Monday, 2 January 2023

Pascal Roobrouck

OBJECTIVES

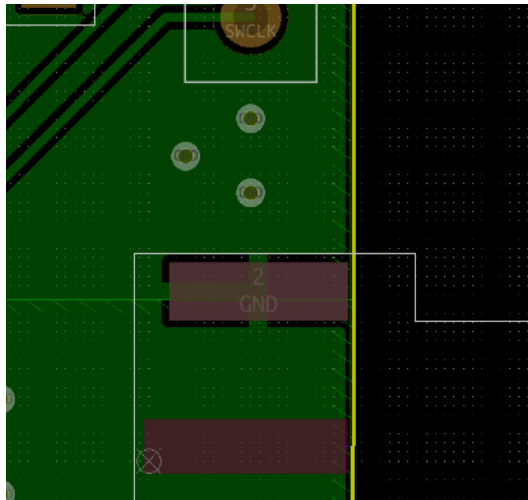
-
- ● U6 is placed on the bottom side for an unknown reason.
 - ● The D+/D- differential pair is not impedance-controlled. The recommendation is a minimal clearance of 0.127 mm (at JLCPCB without a negative price impact). The trace width is about 0.8 mm. The pair is short, so this can be omitted.
 - ● The CONN5 edge SMA was designed to be used on 1.6 mm PCBs. The used PCB layout is designed on a 1.0-1.1 mm thick board.
 - ● PCB constraints corrected set for most of the low-cost PCB manufacturers.
 - ● It is recommended to lay out routes from U3.5 and U3.6 the following way:
